**CALIFORNIA COASTAL COMMISSION**

**COASTAL DEVELOPMENT PERMIT AMENDMENT APPLICATION**

**Application number** .....4-83-490-A2, Cliffs Hotel Revetment Removal and Blufftop Utilities

**Project description** .....Removal of rock revetment at base of bluffs below the Cliffs Hotel and removal, phased (future) abandonment in place, and/or relocation of several structures in the blufftop (including sewage holding tank, sewer lift station, utility lines, pathway, and landscaping). After-the-fact recognition and phased (future) relocation of sewer collection lines.

**Figure 1 - Facility Relocation Plan - Cliffs Hotel**

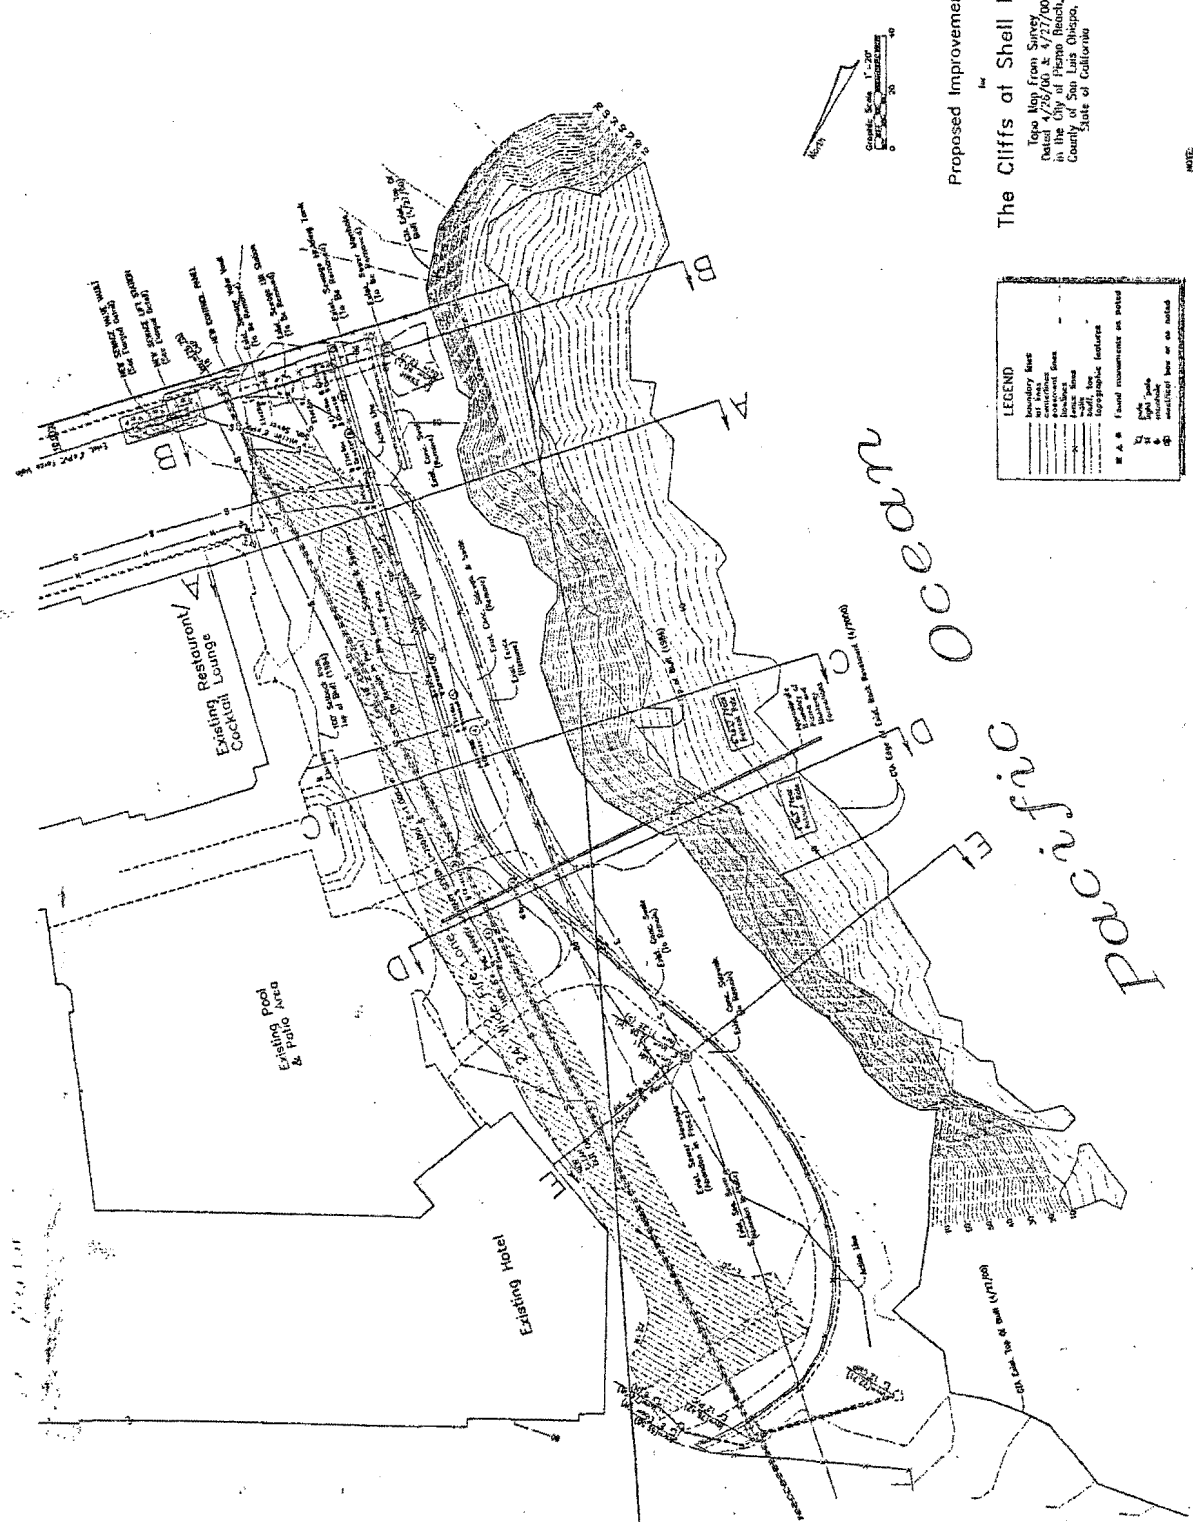
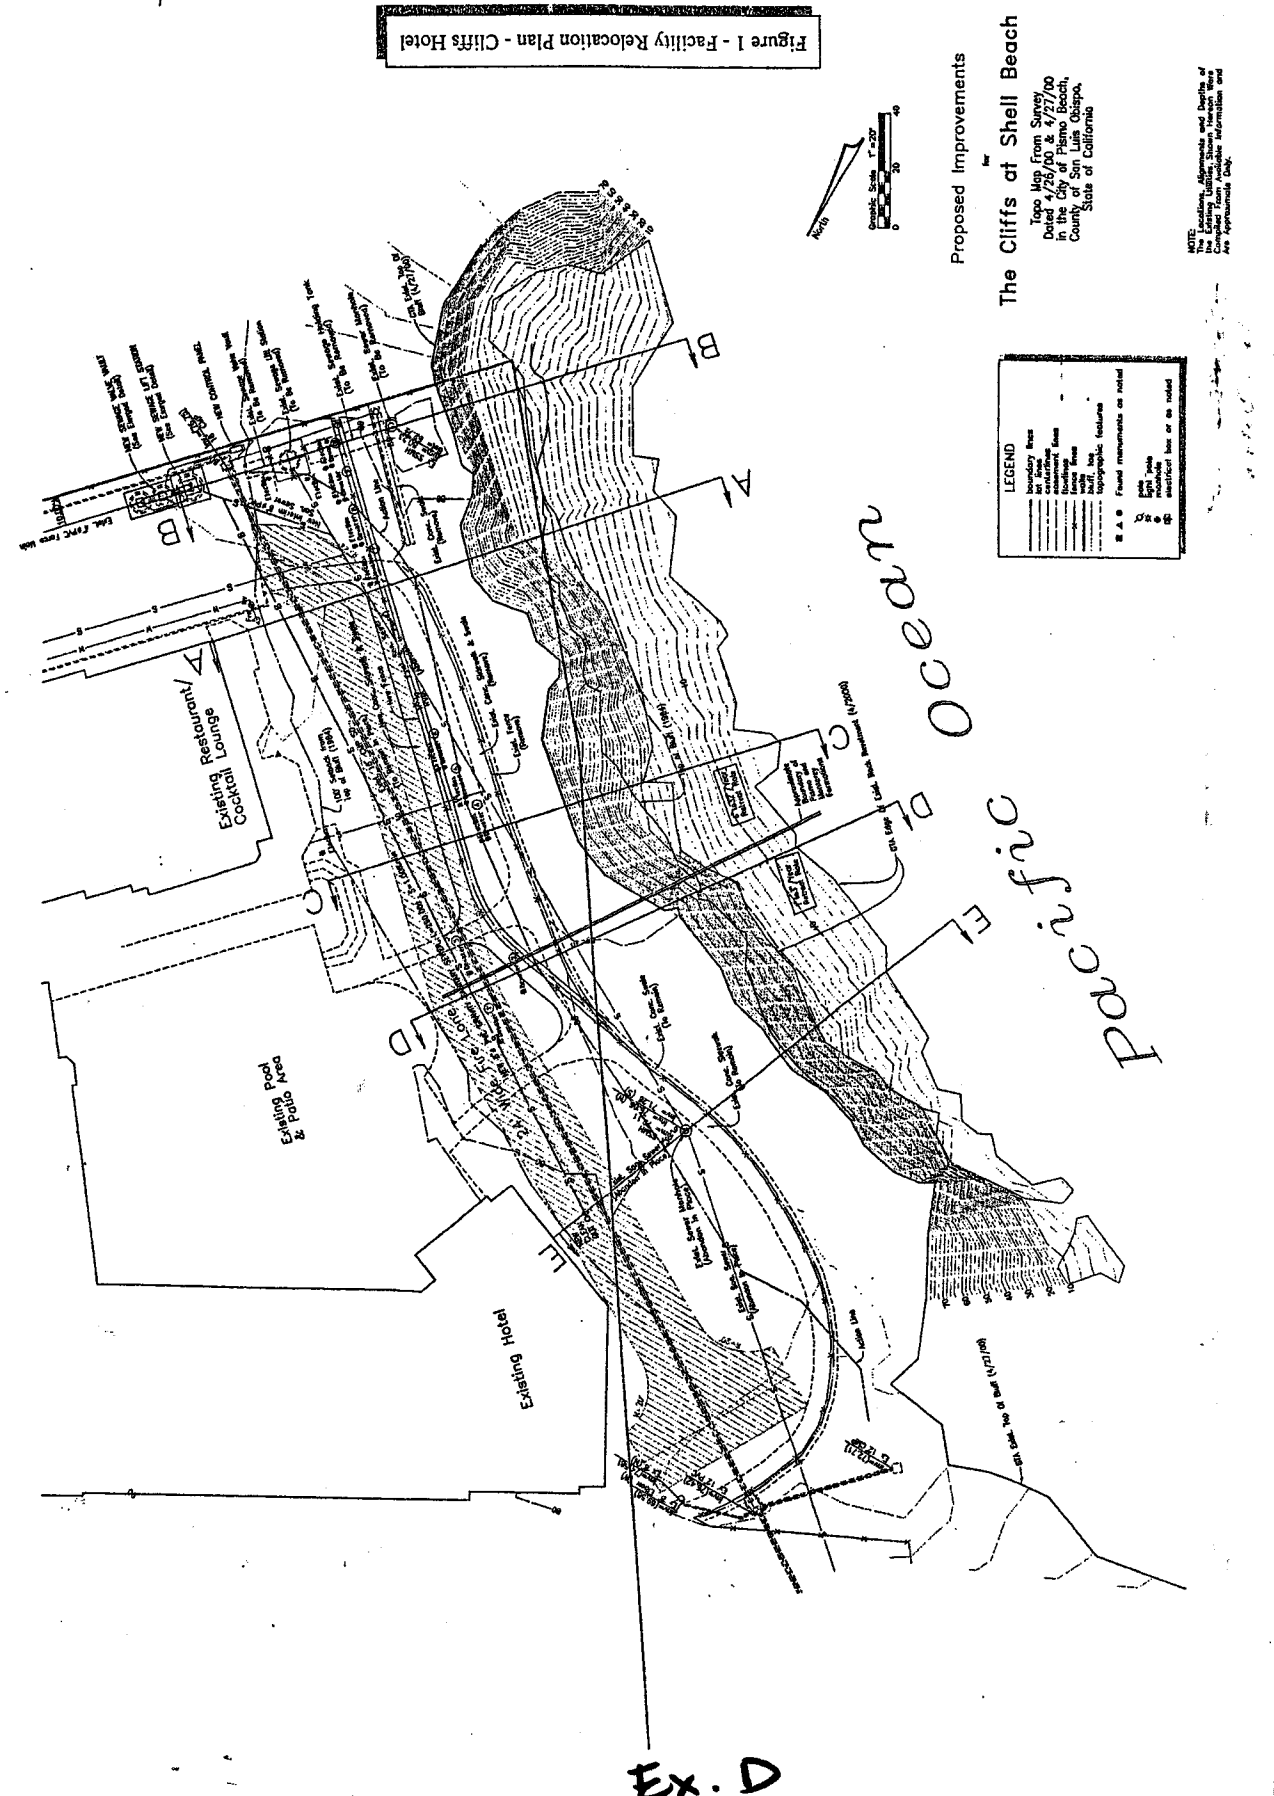
- (d) **Fire Lane.** The "Fire Lane" notation shall be eliminated from the Revised Project Plans. Plan notes may indicate that the blufftop seaward of the Cliffs Hotel is available for emergency access response, but the plans shall not demarcate a formal area for this purpose.

- (e) **Action Line.** The "Action Line" notation shall be eliminated from the Revised Project Plans.
- (f) **Native Blufftop Plantings.** The Revised Project Plans shall indicate via plan notes that all native blufftop plantings shall be drought and salt tolerant native species consistent with bluff vegetation indigenous to the Pismo Beach area, and that these native species shall be maintained in good growing condition in all areas seaward of the any public access pathways at all times.

The Applicant has clarified in several places (both in the submitted plan and by letter correspondence) that the Action Line is not the point when armoring is required, but rather the point at which it would need to be pursued. However, the proposed "facility relocation plan" is both unclear and internally inconsistent on this point.

As shown on Figure 1, in the southern portions of the blufftop in particular, this fire access has become the defining edge for the limits of public access paths, surface storm drainage intercept swales and landscaping. In order to maintain the various utilities and public access that must occur oceanward of the hotel, and to maintain emergency access to the blufftop area, we

As with the physical developments proposed in the blufftop (i.e., sewer lines and drainage apparatus), a fire lane is not allowed in the LCP-required blufftop setback area, it is not allowed by the underlying property restrictions, and it would not be set back a sufficient distance from the bluff to provide a 100 year setback and would thus not negate the need for future shoreline armoring. As a result, it would be inconsistent with the LCP and the underlying property restrictions. Further, as indicated by the Pismo Beach Fire Department, the blufftop seaward of the Cliffs Hotel would not be used for vehicles regardless. Rather, it would be used for foot transport of ladders, if at all. There is no need to designate such an area as a "Fire Lane" (or any other name) to confer this status on the area. The blufftop is, de facto, an emergency access area. The same could be said for the courtyard, the pathway running along the northern side of the Hotel, the parking lot, and indeed any area surrounding the Hotel. To ensure that the "Fire Lane" or its equivalent is not used to justify shoreline armoring requests (armoring that would bring with it its attendant negative coastal resource impacts), and although it can be indicated that the blufftop may be used for emergency access (as it de facto is now), revised plans must be submitted that remove the "Fire Lane" designation from the blufftop area (see special condition 8). Only in this way can it be guaranteed that a conceptual designation – a fire lane – will not be used for shoreline armoring justification and will not be inconsistent with the LCP and the underlying property restrictions.

**Figure 3 - Facility Relocation Plan - Cliffs Hotel**

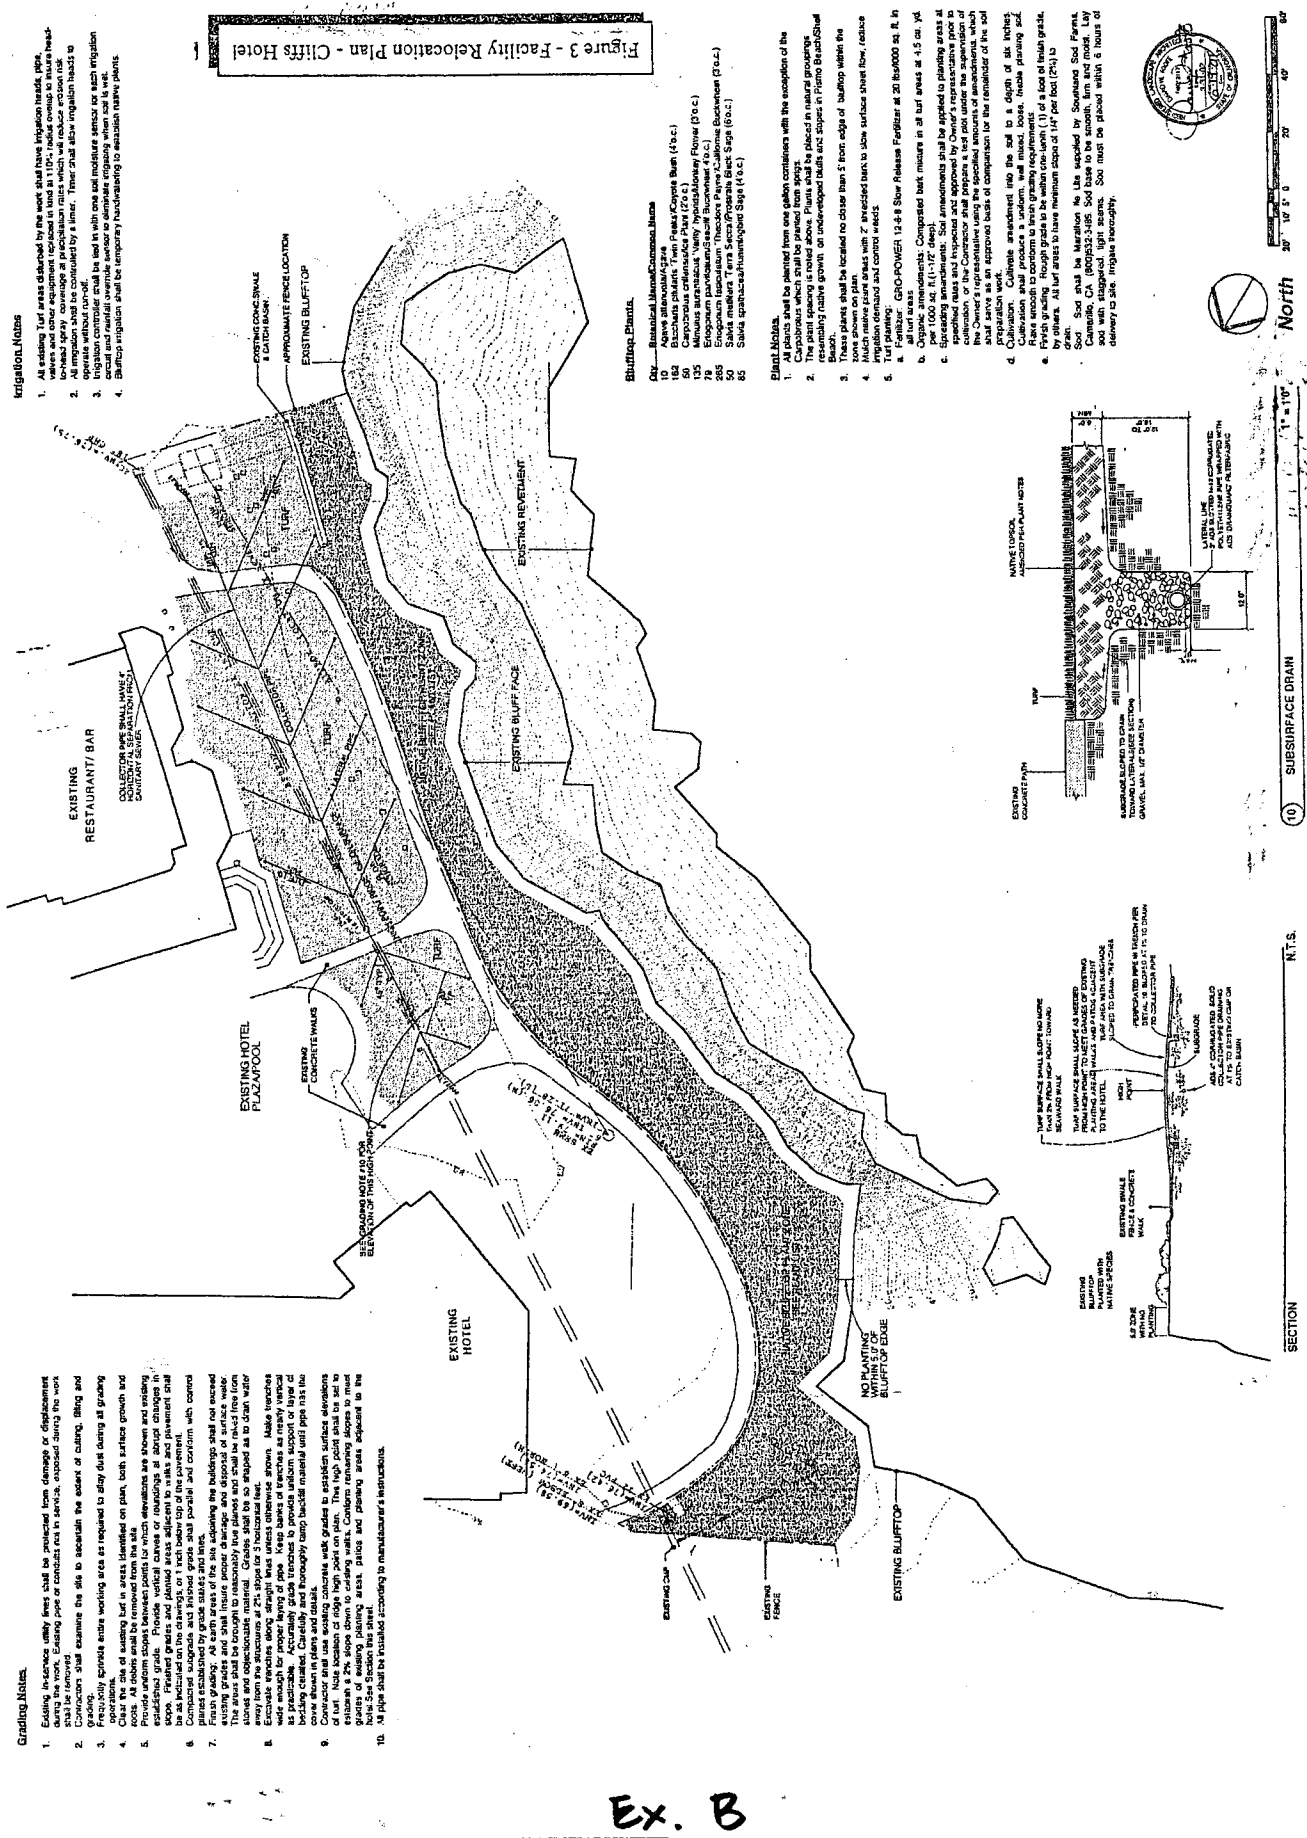
During the 1997 rock revetment installation, the hotel completed various landscape and irrigation improvements that are reflected in the "Phase 1 - Existing" plans (See Figure 3). These improvements will be maintained as they are, and repaired as necessary after Phase I work, which will damage most of the southerly half of the blufftop area (approx. 18,000 SF).

Figure 3 describes one addition to the existing improvements. This addition is a subsurface irrigation drainage system as recommended by the geotechnical engineers for the project. This system would be in-lieu of the geomembrane referred to under the Commission's 1998 permit action.

**Figure 4 - Facility Relocation Plan - Cliffs Hotel**

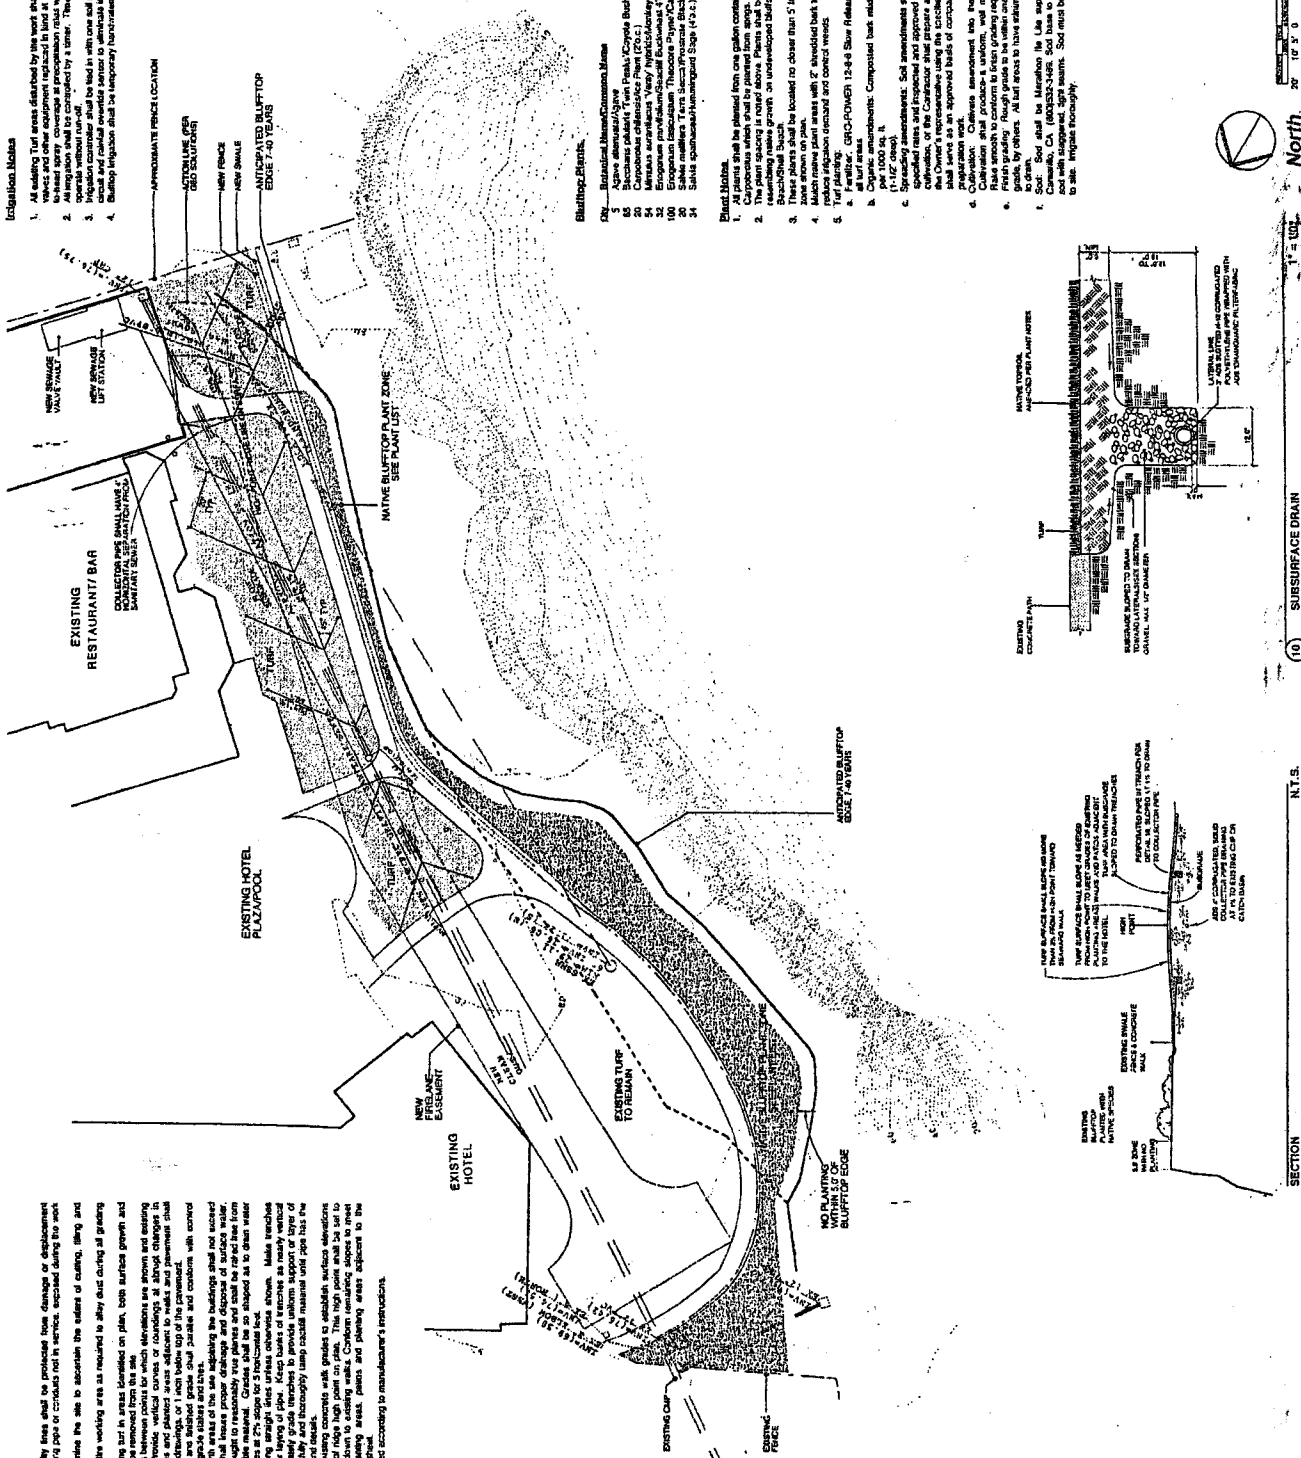
The enclosed Landscape Plan by Firma (Figure 4; June 19, 2001), represents a final landscape plan to be used in guiding blufftop reconstruction at the time future erosion retreats near the Action Line referenced above.

- (g) **Landscaping.** The Revised Project Plans shall indicate via plan notes that all blufftop landscaping, including but not limited to the native blufftop plantings, shall be maintained in good growing condition at all times and shall be replaced as necessary with new plant materials to maintain the approved blufftop landscaping configuration.
